INVITATION FOR BID (IFB) IFB NO. GSWA 003-18

LAYON LANDFILL CONSTRUCTION OF CELL 3

ADDENDUM NO. 2

NOVEMBER 1, 2018

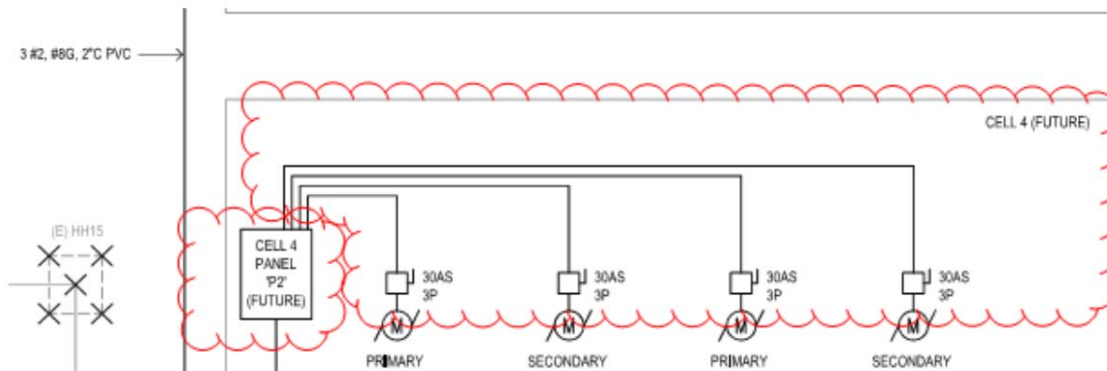
Question #2: Please Confirm if conduits, wires & disconnects are to be provided out to Primary and Secondary Leachate pumps #1 & 2, as referenced in Figure below.

Response: The conduits, wires and disconnects bubbled in figure above for Future Cell 4 are not included in this project. See attached Revision 2 Electrical sheets.
